ONSITE SEWAGE DISPOSAL SYSTEM

PROPERTY ADDRESS: 2018 Terrapin Creek Road

ON SITE SEWAGE DISPOSAL SYSTEM DESIGN PLAN

LOT 20
TERRAPIN CREEK
PLAT 22661 - 22664
TAX ID No. 03-285774
2014 TERRAPIN CREEK ROAD
THIRD ELECTION DISTRICT
HOWARD COUNTY, MARYLAND
SCALE: 1" = 30' JUNE, 2017

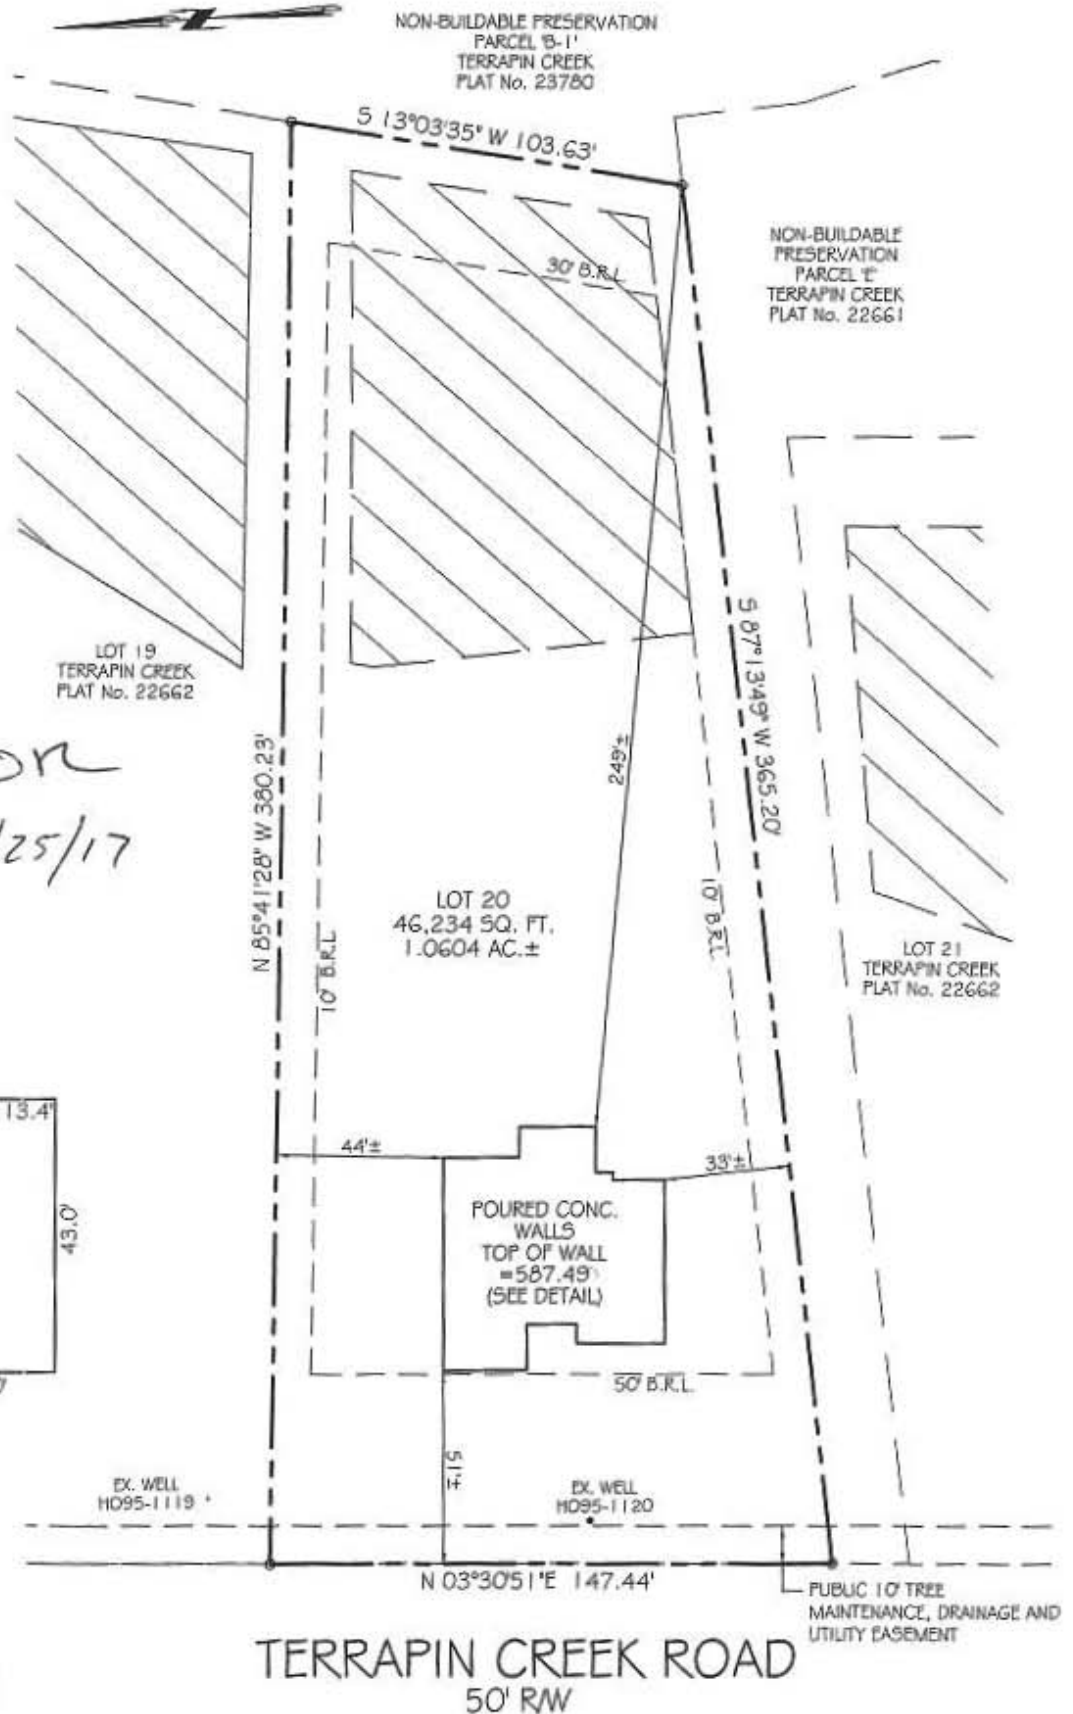
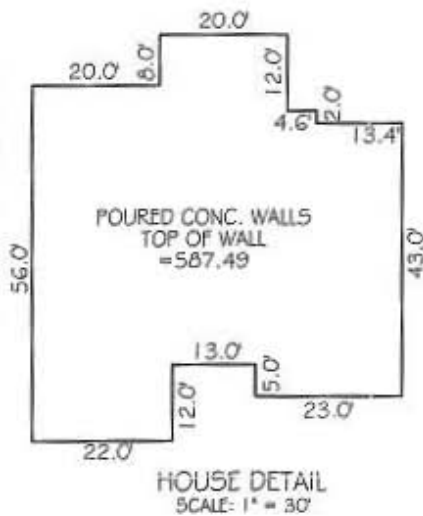
9/26/17 Met WTC on site for layout. SDA corner stakes present - shot contour + laid out 2x47' trenches. Measured tank location off house - okay to set closer to SDA than shown on plan. Builder on site okay with changes. (SC)

9/27/17 site inspection / final inspection - contractor on site, most of the work completed. Trenches look good, tank level. Stone looks good. Contractor using laser to shoot trench bottoms. Observation ports in place, 6" x 4" baffles in place, D-box w/ port looks good. levelers in place w/ even distribution. OK to backfill. (RP)

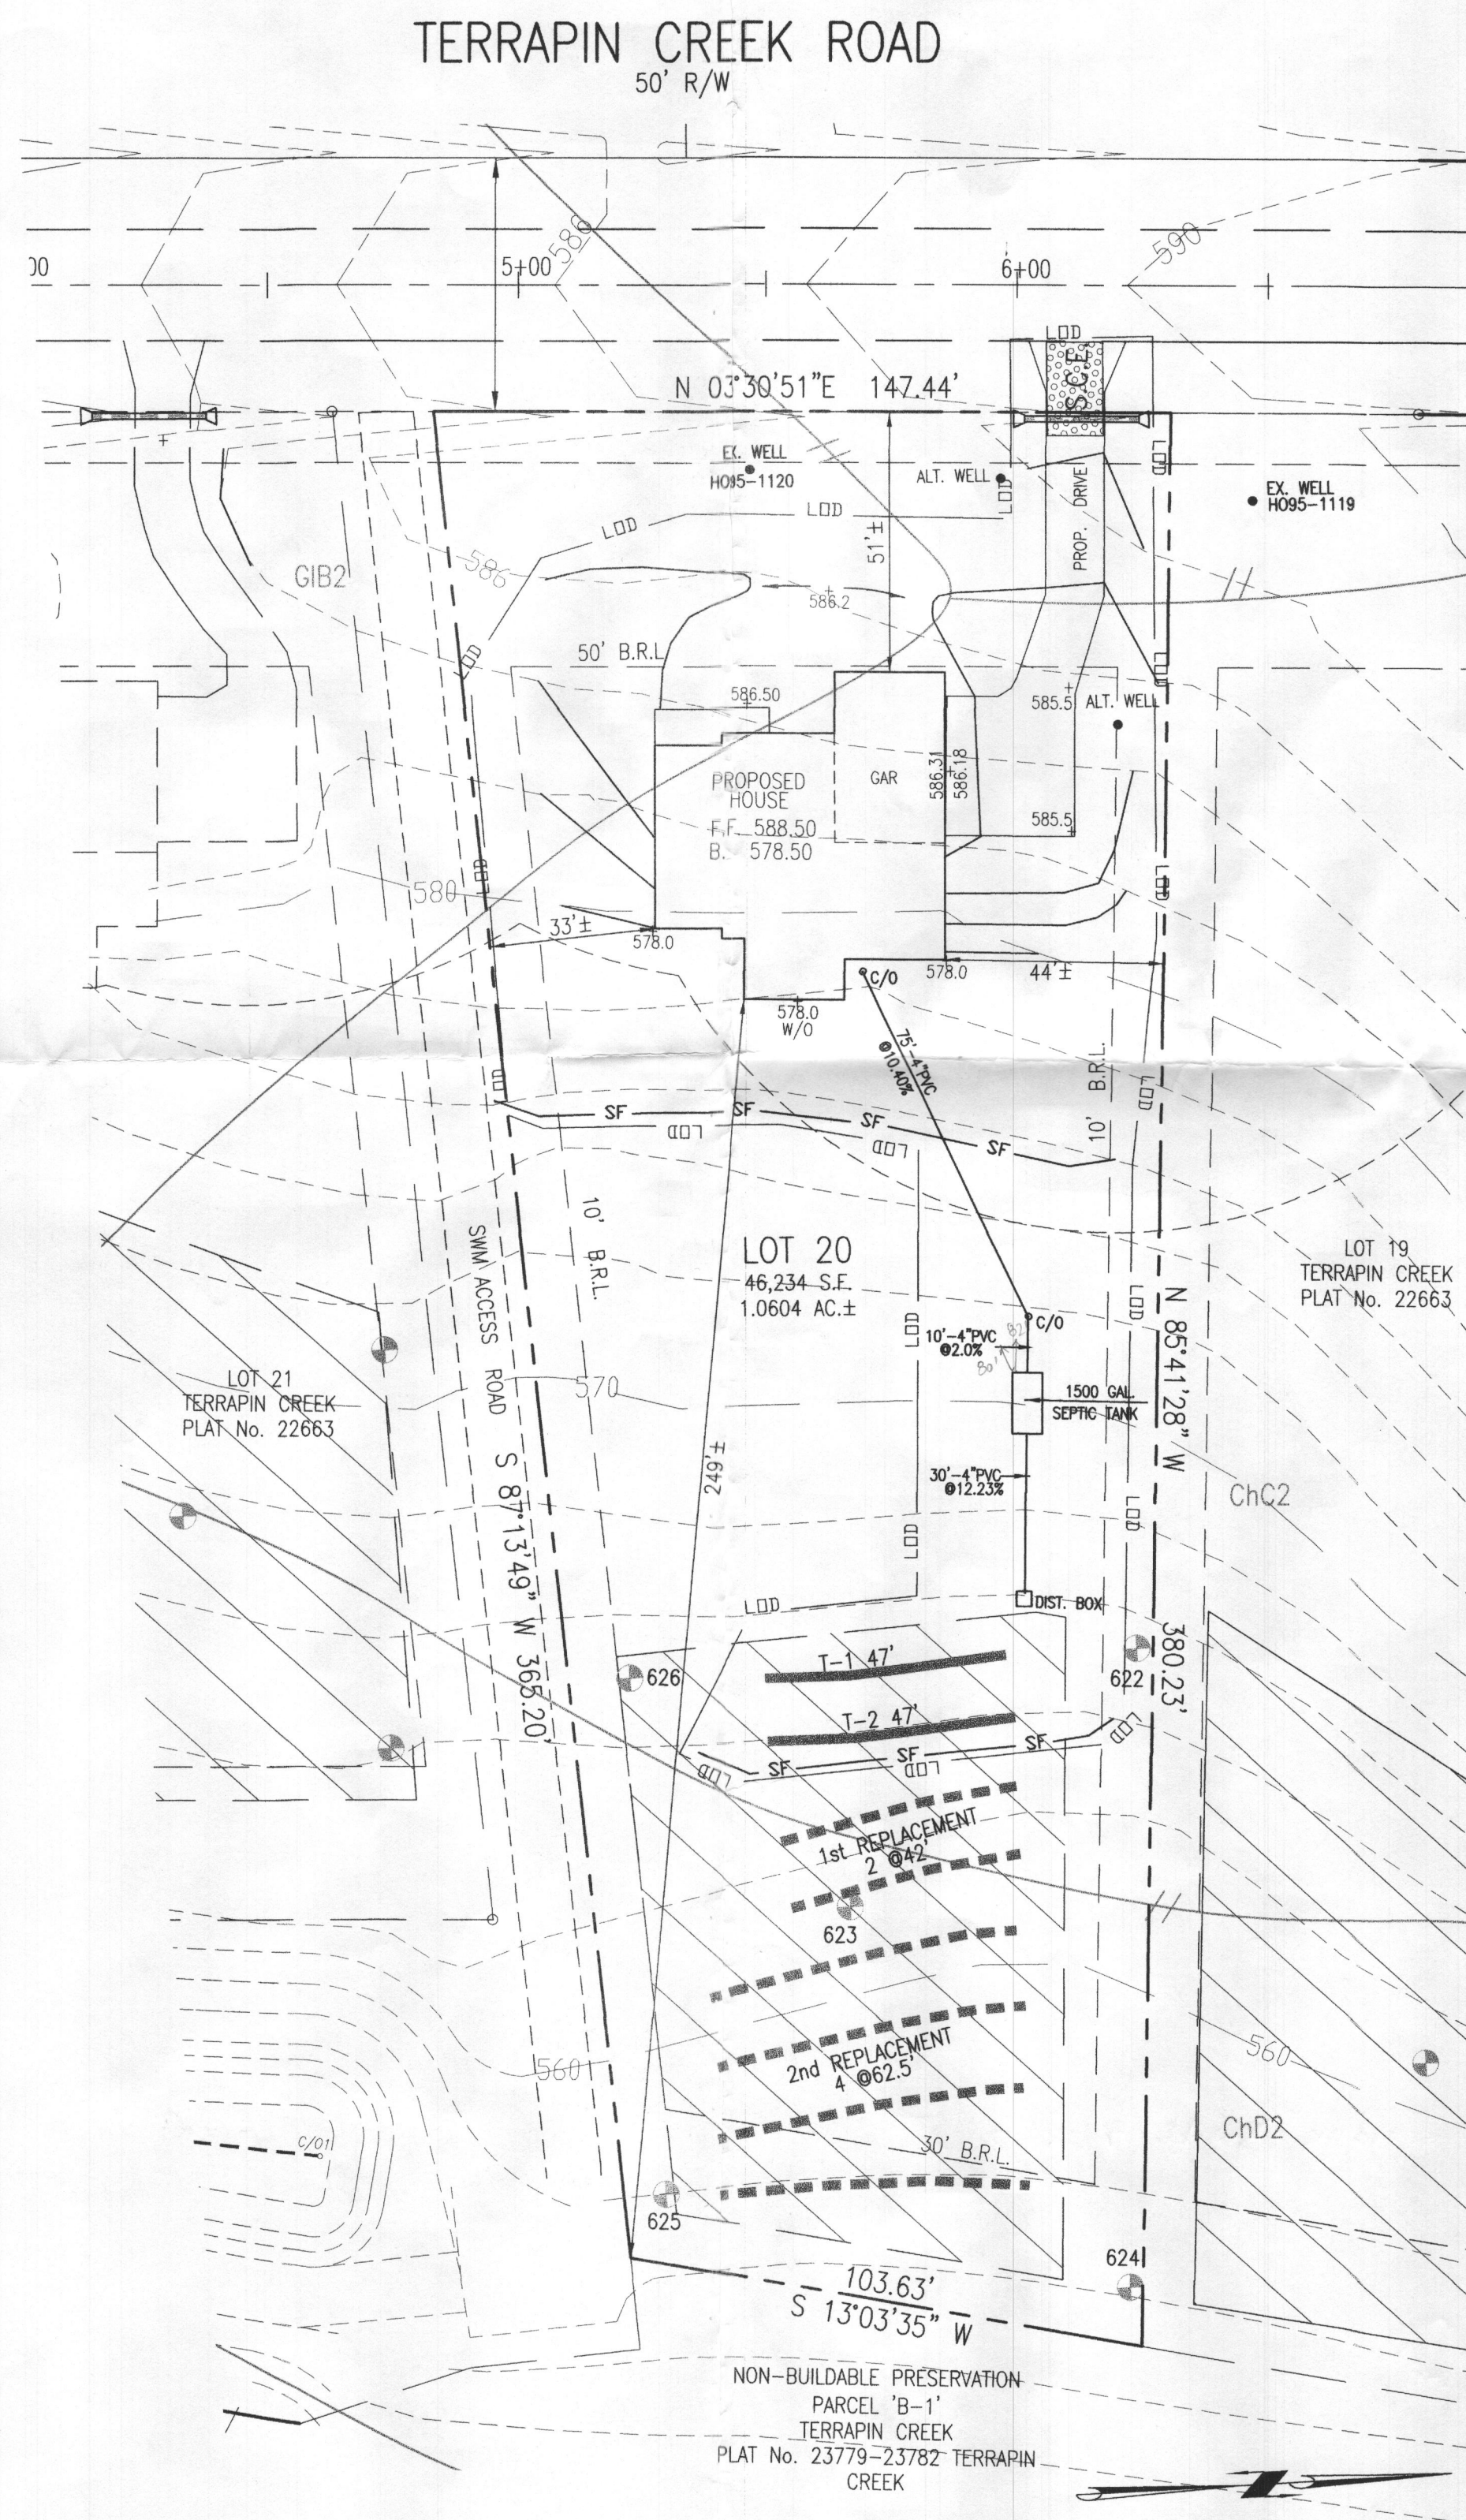
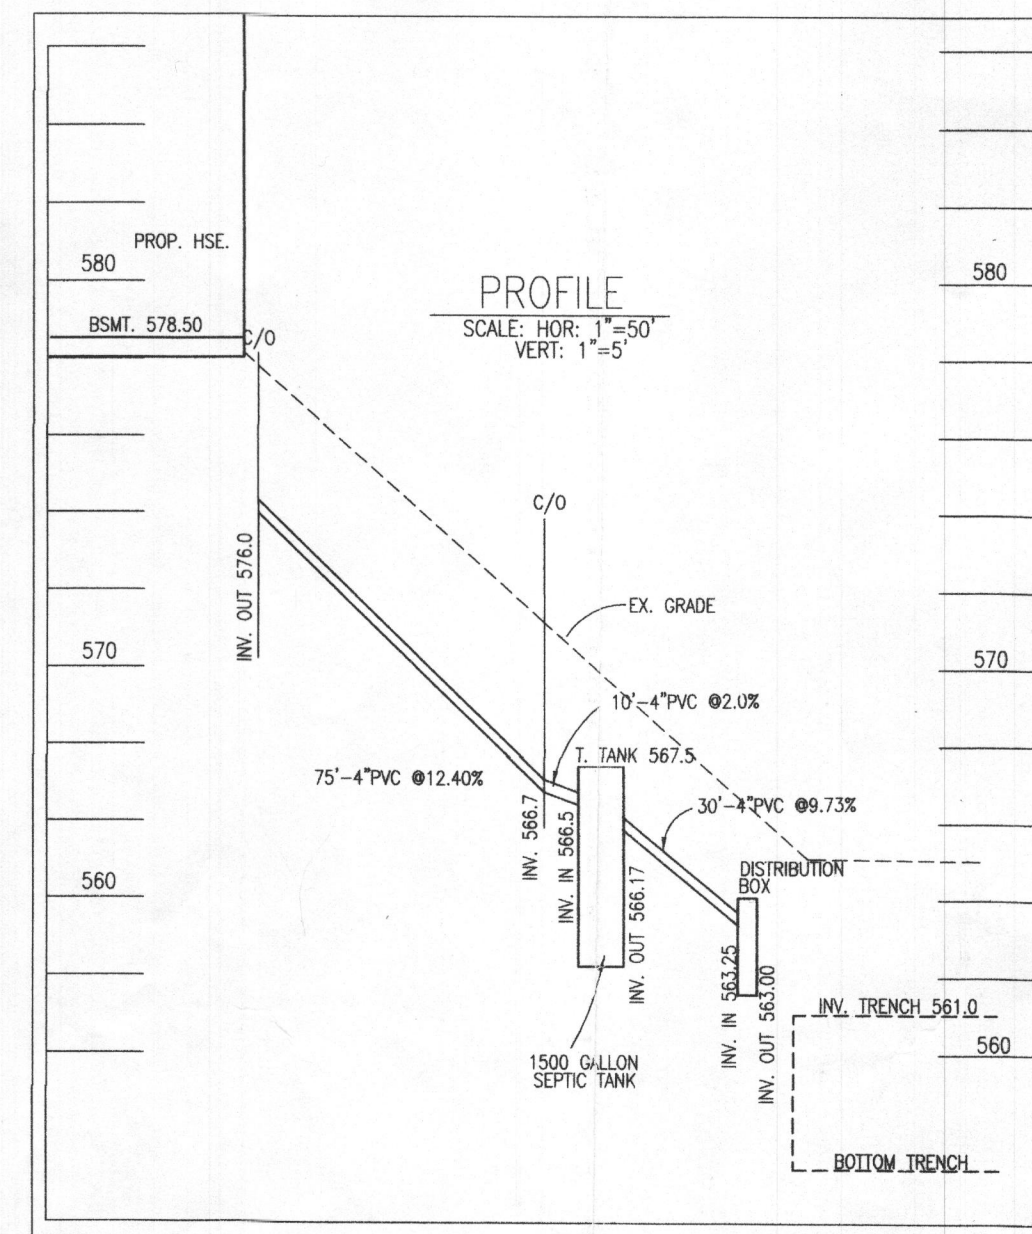
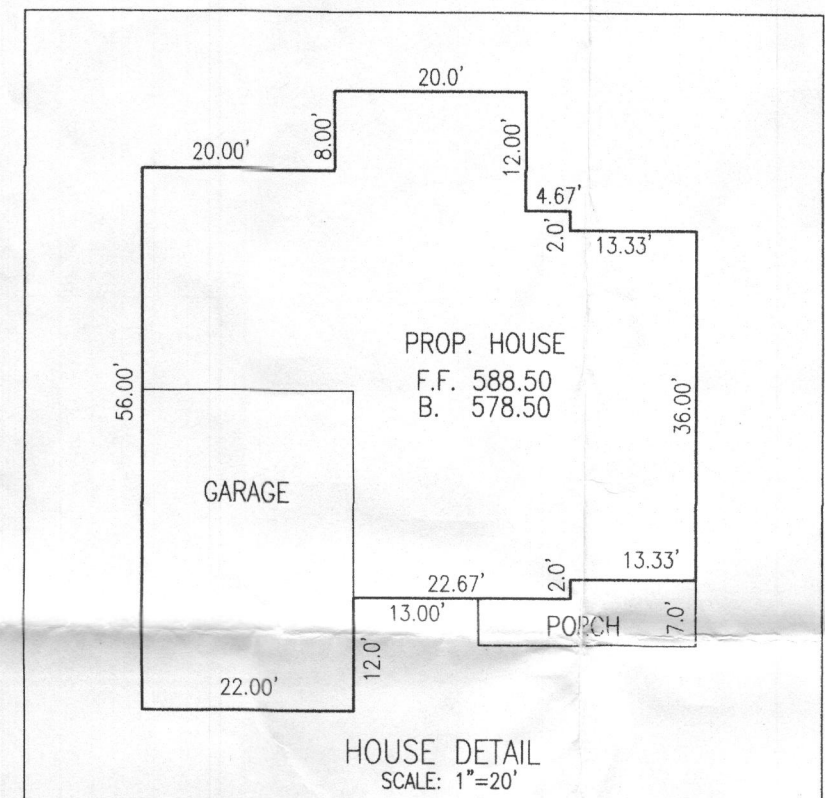
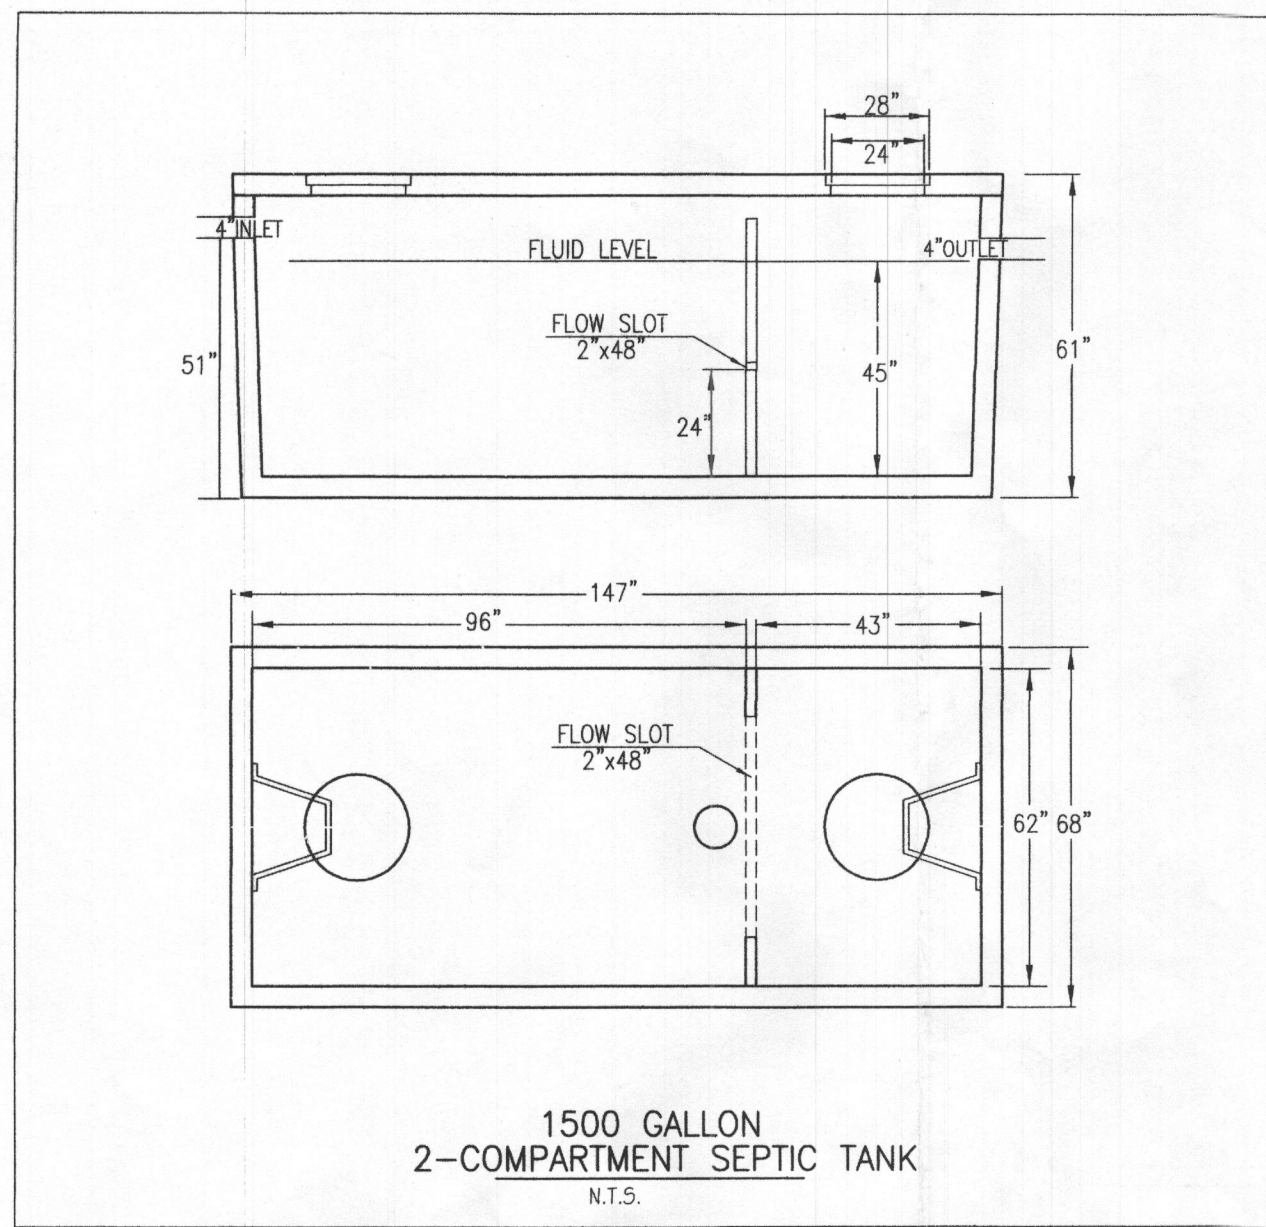
I reviewed the OSDS Plan for 2014 Terrapin Creek, Lot 20 and noticed that the application rate on the 2nd replacement system was still incorrect and there is no sidewall credit for the 2nd system.

Please revise the plan accordingly. Let me know if you have any questions.

The OSDS Plan for Terrapin Creek, Lot 20 has been reviewed with the following comment:

- 1.) Change 2nd replacement system specs to match worksheet (attached)

2nd REPLACEMENT

INITIAL NUMBER OF BEDROOMS = 4
APPLICATION RATE = 1.2 GPD / sq.ft.
DESIGN FLOW: 150 GPD X 4 BEDROOMS = 600 GPD
600 GPD / 0.8 GPD/sq.ft. = 750 sq.ft.
750 sq.ft. / 3 ft. WIDE TRENCH = 250 LF TRENCH
167 LF TRENCH X 0.50 REDUCTION CREDIT = 84 LF TRENCH
TRENCH 1 EX. GRD=560.5 -INV. TRENCH=556.5 -B. TRENCH=553.5
TRENCH 2 EX. GRD=559.5 -INV. TRENCH=555.5 -B. TRENCH=552.5
TRENCH 3 EX. GRD=558.8 -INV. TRENCH=554.8 -B. TRENCH=551.8
TRENCH 4 EX. GRD=558.0 -INV. TRENCH=554.0 -B. TRENCH=551.0
